Work Order ID 85377

Item Name: Bracket Assembly, RH (Aluminum Doors)

DART SERVICE INSTRUCTION

TO AMEND INSTALLATION INSTRUCTIONS IIN-D412-698 REV. E OR LATER APPROVED REVISION
AND ICA-D412-698 REV. 5 OR LATER APPROVED REVISION

FIGURE 2: D3675-5/-6 BRACKET INSTALLATION ON COMPOSITE DOORS
(-6 SHOWN, -5 OPPOSITE)

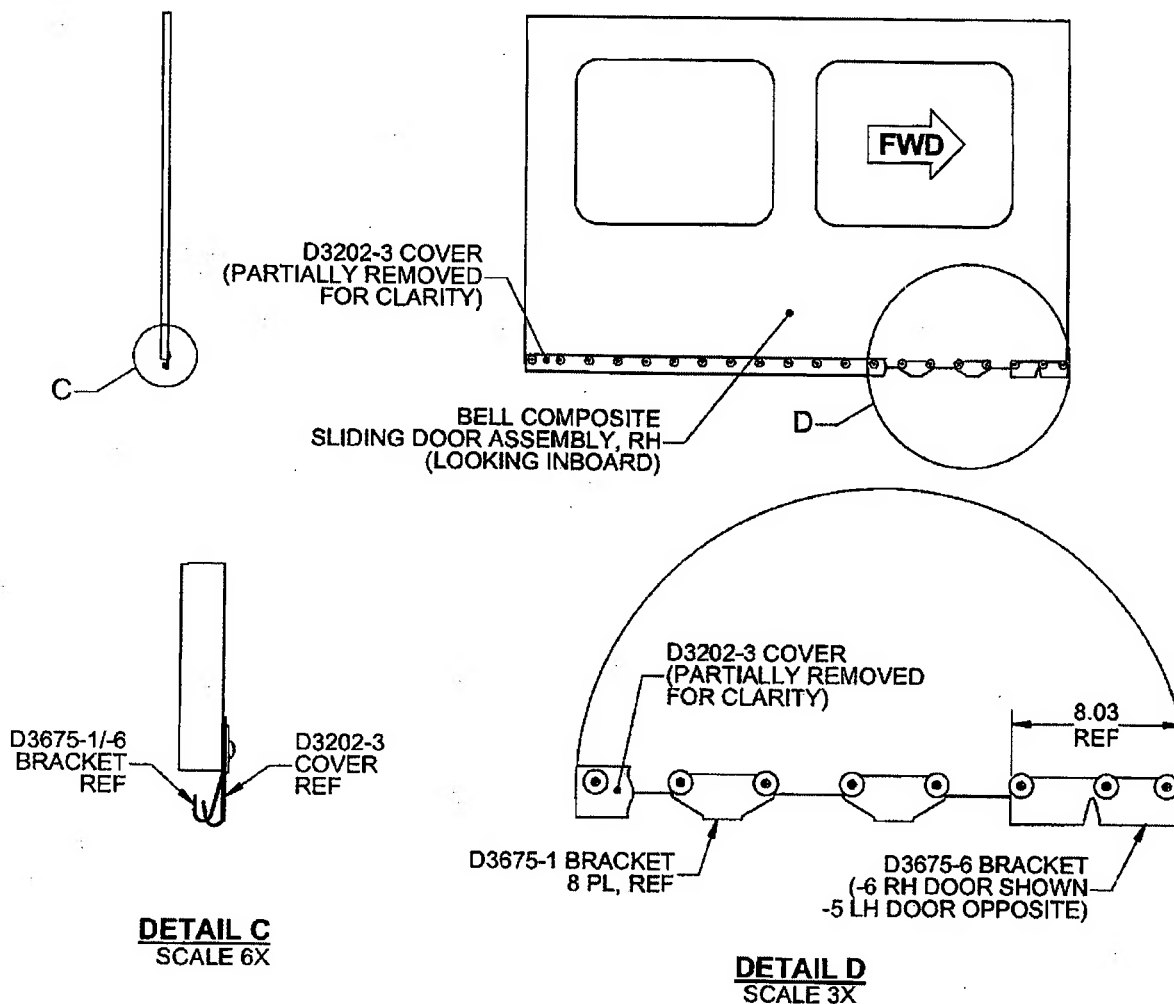
Field experience has shown that the forward D3199-1 brackets that are part of the D412-698-011/-012/-017 Cabin Door Roller Kits and forward D3675-1 brackets that are part of the D412-698-031/-032/-033 Cabin Door Roller Kits may wear prematurely if the aircraft is flown a significant amount of time with the sliding doors open. Dart has developed the D412-698-027/-028 kits that includes a longer D3199-3/-4 bracket for installation in the first forward position of the D412-698-011/-012/-017 kits to reduce wear on these forward brackets on aircraft equipped with aluminum doors. Likewise, Dart has developed the D412-698-037/-038 kits that includes a longer D3675-5/-6 bracket for installation in the first forward position of the D412-698-031/-032/-033 kits to reduce wear on these forward brackets on aircraft equipped with composite doors.

- 1) Remove the sliding door from the aircraft per Section 52.1 of ICA-D412-698
- 2) Remove the first forward D3199-1 or D3675-1 brackets as applicable.
- 3) Install the D3199-3/-4 or D3675-5/-6 bracket as applicable in lieu of the removed -1 bracket. Refer to Figure 1 Sheet 2 (aluminum doors) or Figure 2 Sheet 3 (composite doors).
- 4) Torque hardware per ICA-D412-698.
- 5) Re-install sliding door on aircraft per Section 52.2/52.3 of ICA-D412-698 as applicable.
- 6) Make entry in technical records of aircraft indicating that DSI 9484 has been completed.

FIGURE 2: D3675-5/-6 BRACKET INSTALLATION ON COMPOSITE DOORS
(-6 SHOWN, -5 OPPOSITE)

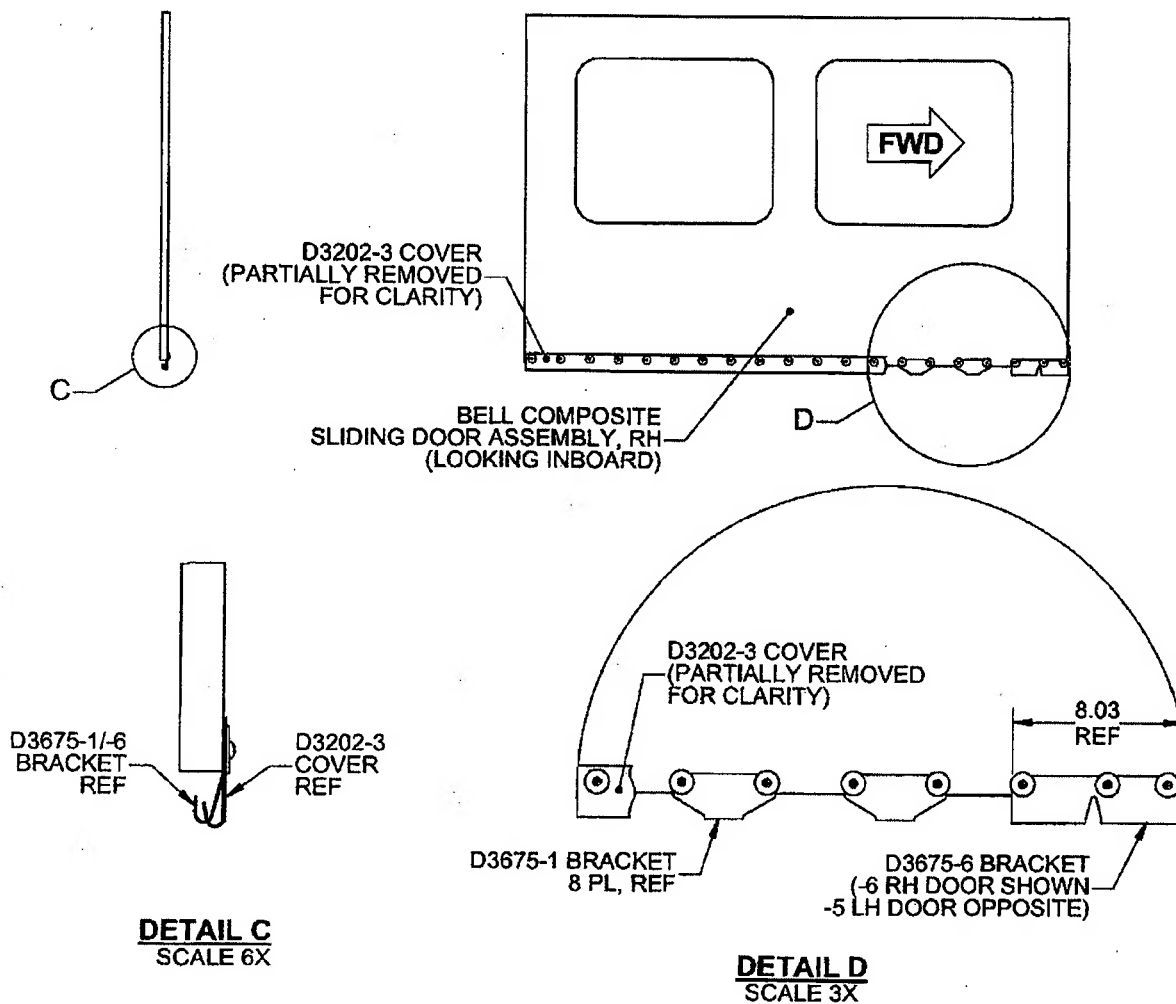
Field experience has shown that the forward D3199-1 brackets that are part of the D412-698-011/-012/-017 Cabin Door Roller Kits and forward D3675-1 brackets that are part of the D412-698-031/-032/-033 Cabin Door Roller Kits may wear prematurely if the aircraft is flown a significant amount of time with the sliding doors open. Dart has developed the D412-698-027/-028 kits that includes a longer D3199-3/-4 bracket for installation in the first forward position of the D412-698-011/-012/-017 kits to reduce wear on these forward brackets on aircraft equipped with aluminum doors. Likewise, Dart has developed the D412-698-037/-038 kits that includes a longer D3675-5/-6 bracket for installation in the first forward position of the D412-698-031/-032/-033 kits to reduce wear on these forward brackets on aircraft equipped with composite doors.

- 1) Remove the sliding door from the aircraft per Section 52.1 of ICA-D412-698
- 2) Remove the first forward D3199-1 or D3675-1 brackets as applicable.
- 3) Install the D3199-3/-4 or D3675-5/-6 bracket as applicable in lieu of the removed -1 bracket. Refer to Figure 1 Sheet 2 (aluminum doors) or Figure 2 Sheet 3 (composite doors).
- 4) Torque hardware per ICA-D412-698.
- 5) Re-install sliding door on aircraft per Section 52.2/52.3 of ICA-D412-698 as applicable.
- 6) Make entry in technical records of aircraft indicating that DSI 9484 has been completed.
